ICC A117.1 STANDARD
UNRESOLVED ISSUE REPORT
Stemming from
SECOND PUBLIC REVIEW DRAFT

ICC/ANSI A117.1 STANDARD
DEVELOPMENT - 2015 EDITION

Unresolved Issue Request #24B (6-37-12 PC1) Lavatory Basin Setback

To: A117.1 Committee Members
From: Kermit Robinson – staff secretariat
Date: June 15, 2015 – **Updated October 1, 2015**

K-2907-1

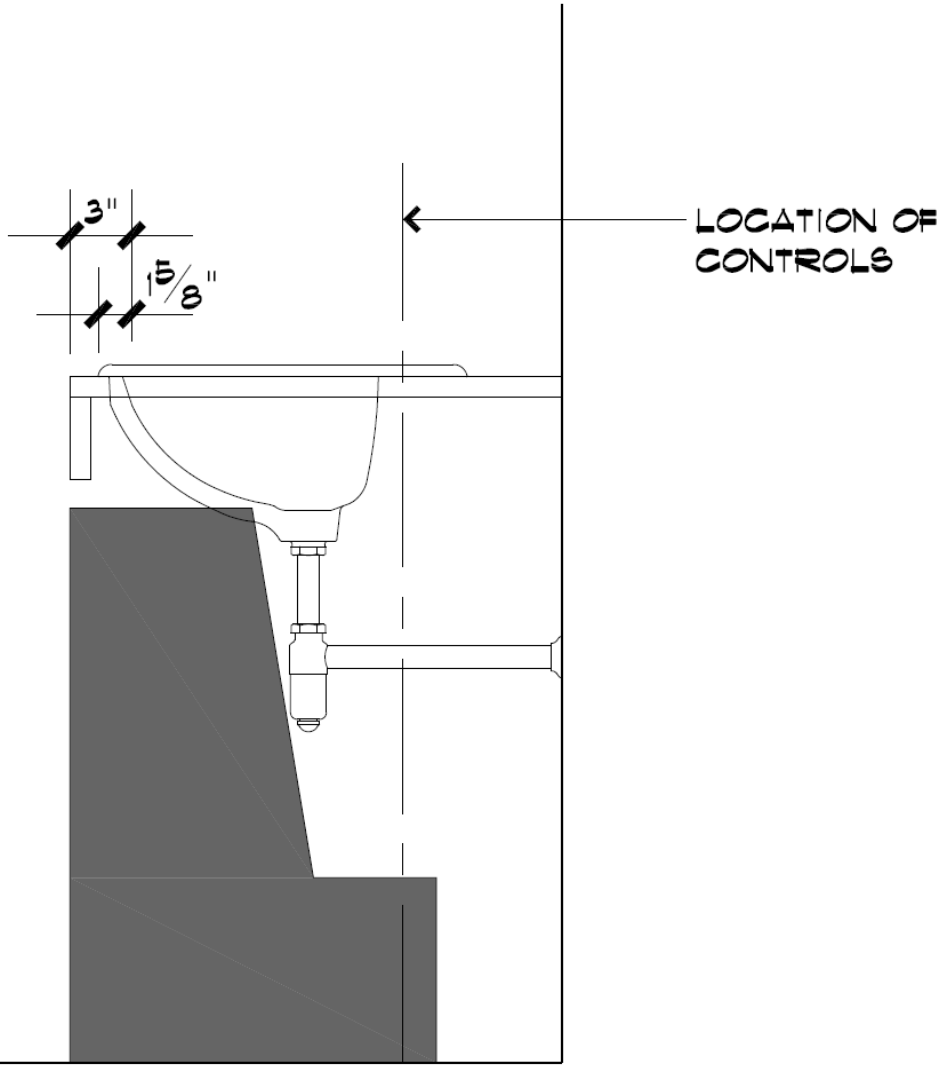
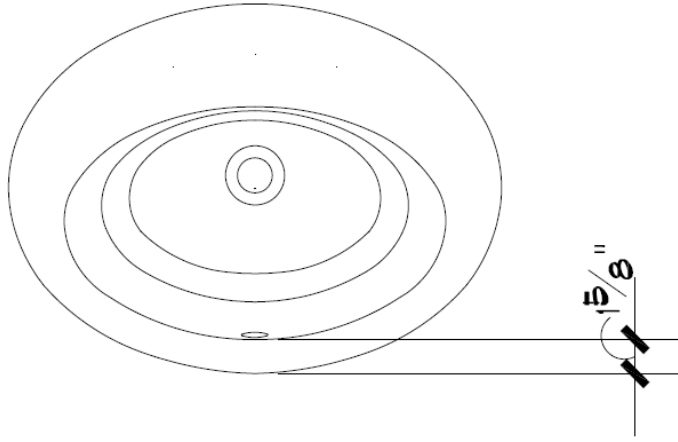
606.5 Basin Location. The interior edge of the rim of the lavatory basin shall be located 3 $\frac{1}{2}$ inches (~~75~~ 90 mm) maximum from the front edge of the fixture or countertop.

Reason: At the current 3” from the front edge most sinks would not be able to comply with the required knee clearance. It would be impossible to meet the 8” deep requirement.
